Re: Responses to City of Burlington Comments dated November 6, 2020, Noise and Vibration Feasibility Study, Proposed Residential Development, Millcroft Greens Corporation, Burlington, Ontario dated October 6, 2020

We are in receipt of the City of Burlington's comments dated November 6, 2020 in reference to our noise study entitled, "Noise and Vibration Feasibility Study, Proposed Residential Development, Millcroft Greens Corporation, Burlington, Ontario" dated October 6, 2020. The City's comments related to noise and vibration are *italicized* below followed by HGC Engineering's responses.

Figure 1 - Key Plan

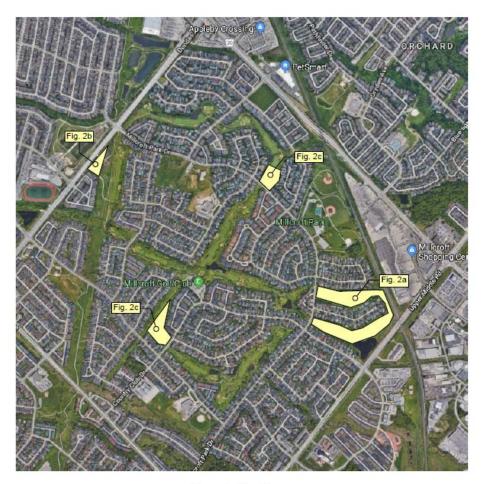
j. Please provide an additional prediction location for the (top) area on Figure 2c at the worst-case scenario for the 16 lot pod, we acknowledge that it is probably similar to "I" but need to see the values in the table.

A prediction location was not included for "the top area on Figure 2c" since that area is far from the major roadways (Dundas, Millcroft, Upper Middle Road) with traffic. The closest proposed residential lot is approximately 65 m from Berwick Drive with one row of existing dwellings. Berwick Drive is a low volume residential road and does not have significant traffic volumes. The sound levels at the additional prediction location is expected to be <55 dBA during the daytime hours and <50 dBA during the nighttime hours.
